SAN ANTONIO WATER SYSTEM PURCHASING DEPARTMENT

Issued By: Sandra Rios
BID NO.: 19-17053

**INFORMAL INVITATION FOR BIDS
FOR PURCHASE, INSTALLATION AND DISPOSAL OF FRONT ENTRANCE AND EXITING
MEDIO CREEK RECYCLING CENTER
ADDENDUM 2**

***** This **Addendum 2** is issued for Bid 19-17053 to do the following:

Pedestal Dimensional Drawing And Specs

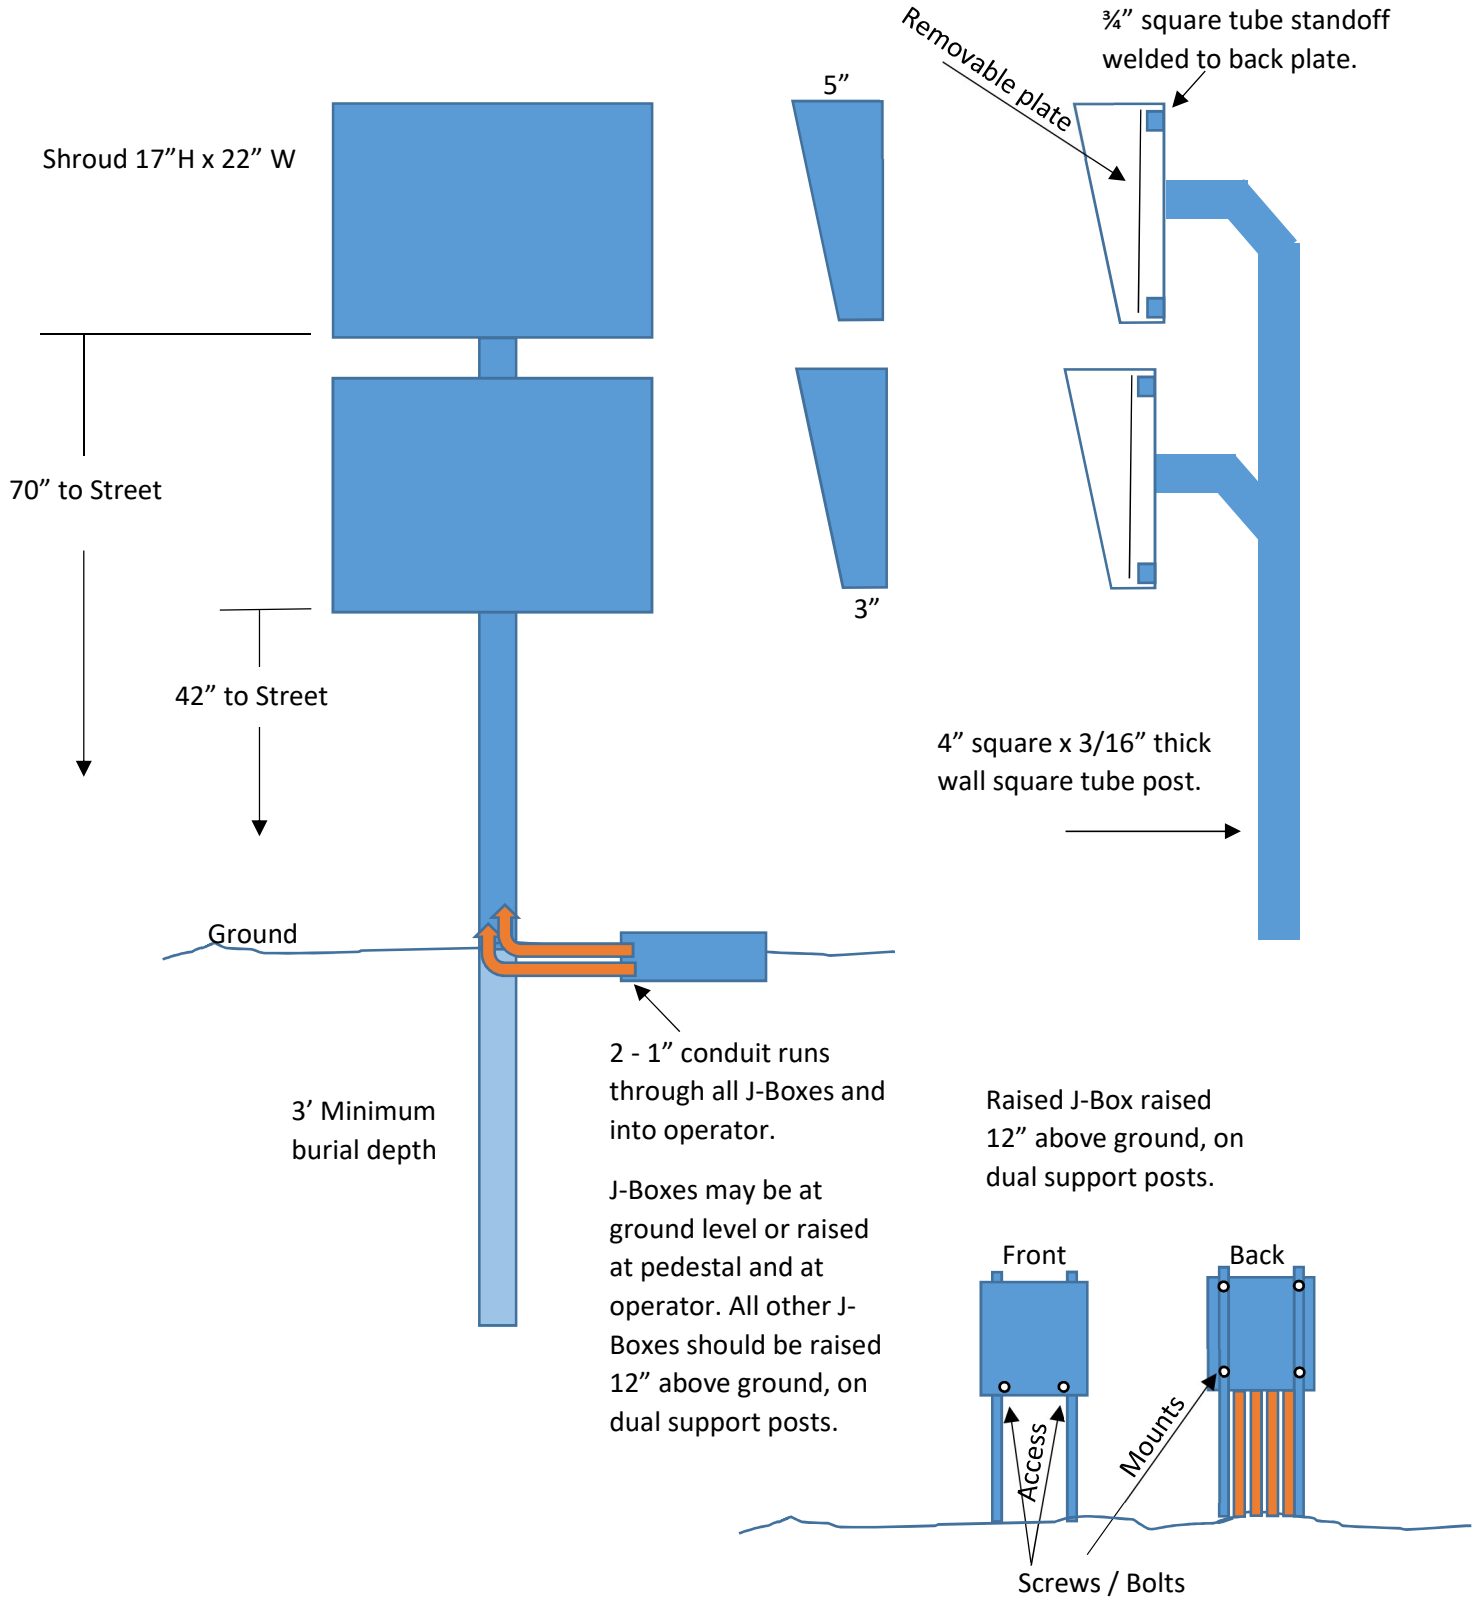
1. As discussed per the site visit a dual height pedestal for controls of the gate operator is required?

2. Is there a basis of design for the pedestal?

11. Can you provide any design details or requirements for the control pedestal and size for any required conduit feed?

Answer: Yes. Details and dimensions below.

Answer: Yes. Details and dimensions are below.

Answer: Yes – Pedestal details are below.
